Access Compliance Report

Public Rights-of-Way

(Curb Ramps)

Intersection ID: 52135	Main Street: ARDREY_KELL_RD	Cross Street: JUNIPER_TRACE_DR	Location: NE
ADA ID: 82FF4BDD290C	Ramp Type: PerpDiag	Initial Pass/Fail: Fail	Overall Compliance: No
Severity Score: 8.75			
Codes/Mitigation Info/Possible Solution		Field Measurements/Component Compliance

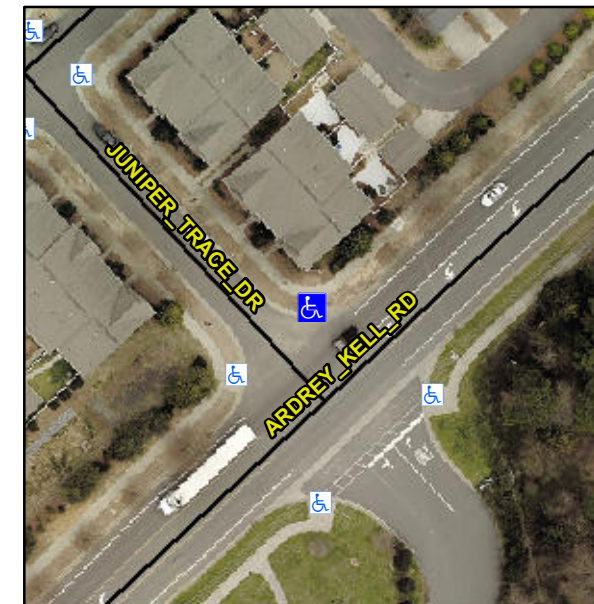
Not Found, R304.5.1

Compliance	Description	Data	Compliance	Description	Data
N/A	Ramp Length (in)	95.0	Yes	Ramp Slope (%)	7.4
No	Ramp Width (in)	46.0	Yes	Ramp XSlope (%)	1.3
N/A	Flare Type LT	N/A	N/A	Flare Type RT	N/A
N/A	Flare Slope LT (%)	N/A	N/A	Flare Slope RT (%)	N/A
N/A	Flare Traversable LT?	N/A	N/A	Flare Traversable RT?	N/A
N/A	Landing Length (in)	N/A	N/A	DWS Provided?	N/A
N/A	Landing Width (in)	N/A	N/A	DWS Contrast?	N/A
N/A	Landing Slope (%)	N/A	N/A	DWS Length (in)	N/A
N/A	Landing X Slope (%)	N/A	N/A	DWS Full Width?	N/A
N/A	Landing Curb? (Y/N)	N/A	N/A	DWS Offset (in)	N/A
N/A	Shared Landing?	N/A			
N/A	Gutter Ponding?	N/A	N/A	Gutter Slope (%)	N/A
N/A	Gutter Lip Ht (in)	N/A	N/A	Gutter X Slope (%)	N/A
N/A	Painted X Walk1?	No	N/A	Painted X Walk2?	No
	X Walk 1 Direction	To SW		X Walk 2 Direction	To SE
N/A	X Walk 1 Width (in)	N/A	N/A	X Walk 2 Width (in)	N/A
	X Walk 1 Slope (%)	0.2		X Walk 2 Slope (%)	2.3
	X Walk 1 X Slope (%)	0.1		X Walk 2 X Slope (%)	0.2

Remove & Replace Curb Ramp With Two New Directional Ramps or Equivalent.
